Hybrids Phase III: Manual 10 and 14D Changes

Operating Committee
May 8, 2025

- Hybrids Phase III filing accepted March 28, 2025
 - FERC Docket #ER25-1095-000
- Changes included allowing more than just inverter-based resources with storage components
- Updated Open-Loop and Closed-Loop classifications of Hybrid Resources

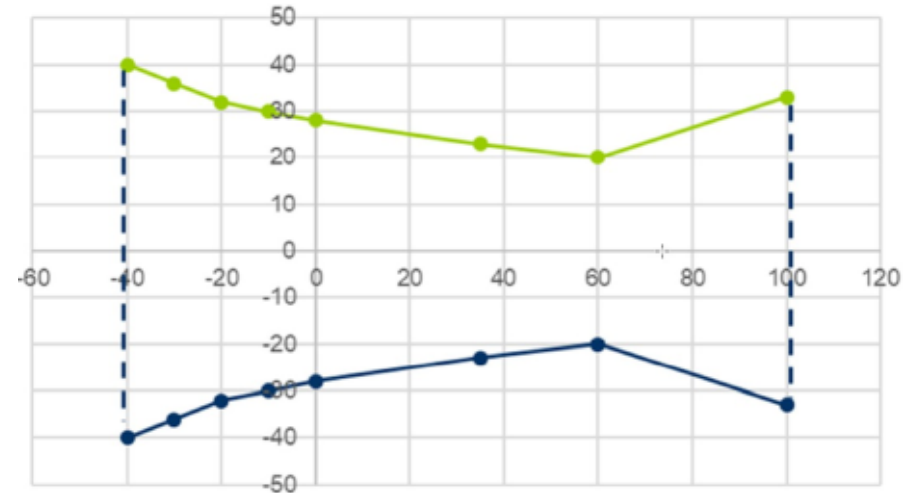
- Section 13.1 Marketing and Classification of Mixed Technology Facilities
 - Modified language to broaden eligibility to participate as a Hybrid Resource
 - Clarified classifications of open-loop and closed-loop based on definition changes
 - Updated language and diagram to be inclusive of all eligible resource types for hybrids
 - Updated language to specify when a Mixed Technology Facility must participate as a Hybrid Resource
 - Noted classification of closed-loop for any Hybrid Resource without storage component
 - Clarified that for all Mixed Technology Facilities participation change notifications must be made no later than six (6) months in advance of its initial start in the energy markets.
